## Comment Set F2 – Southern California Edison

### Attachment A SCE's Transmission Planning Assessment of the DEIR/DEIS's Phased Build Alternative

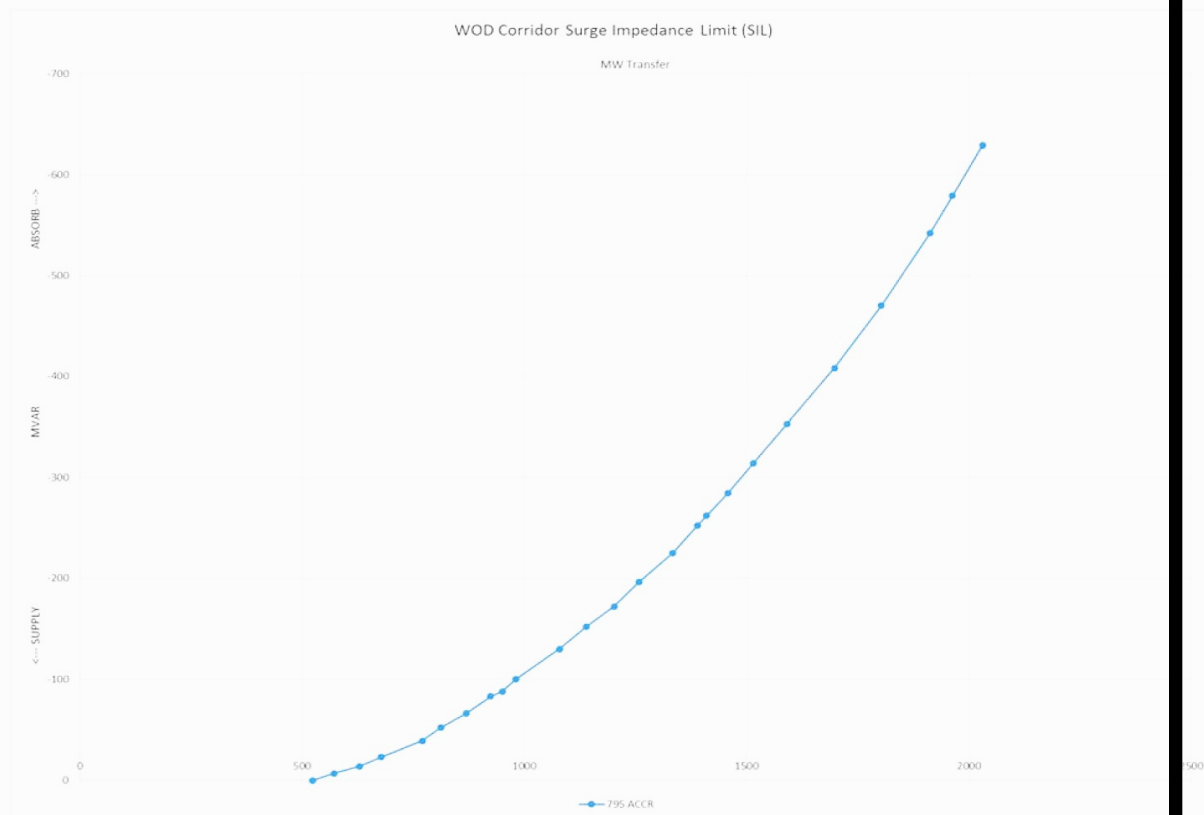
potential for system voltage instability. Thus, the 1,900 MW limitation safeguards against system voltage instability due to the excessively high MVAR losses on the 795 ACCR conductor.

As illustrated in the SIL chart below, the reactive losses on the 795 ACCR conductor are approximately 570 MVAR when the flow through the WOD corridor is approximately 1,900 MW.

Technical review by ZGlobal indicates that the MVARs consumed by the four circuits of the West of Devers corridor using 795 ACCR conductor would be as follows:

■ Devers-Vista	72 MVARs
■ Devers–San Bernardino	49 MVARs
■ Devers–El Casco–San Bernardino	50 MVARs
■ Devers-TOT185HS-Vista	72 MVARs
■ Total:	243 MVARs

This means that the total of 570 MVARs mentioned in SCE comment regarding the Phased Build Alternative may be an overstatement of these losses.
